CONSTRUCTION PLANS
FOR
FONTAINE BOULEVARD & LAMPREY DRIVE
WITHIN LORSON RANCH EAST
STREET, STORM SEWER,
AND WATERMAIN CONSTRUCTION PLANS

FONTAINE BLVD STREET/STORM AND WATER/SEWER CONSTRUCTION LORSON RANCH EAST

DATE: **DECEMBER 20, 2017**
PROJECT NO. **100.041**
SHEET NUMBER **C1.1**
TOTAL SHEETS: 34

**FONTAINE BLVD
SIGNING & STRIPING PLAN**

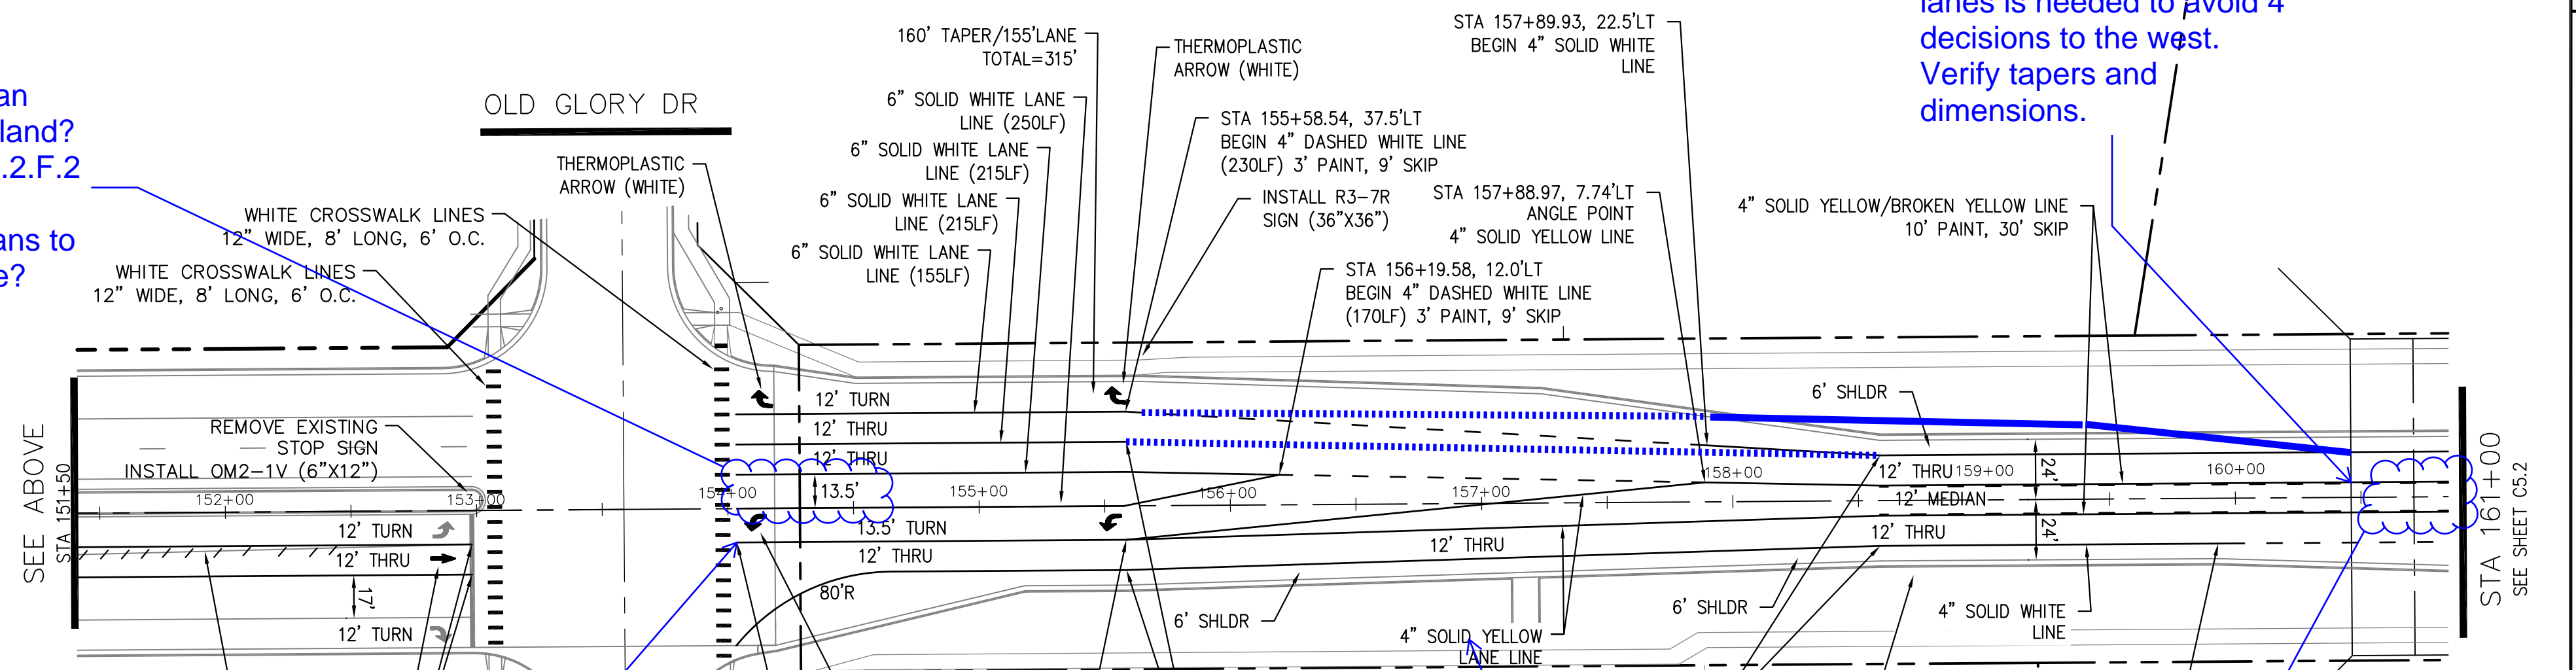
Pedestrian
refuge island?
ECM 2.5.2.F.2
Or direct
pedestrians to
west side?

A WB split to 2 through
lanes is needed to avoid 4
decisions to the west.
Verify tapers and
dimensions.

Add median between
opposing traffic.
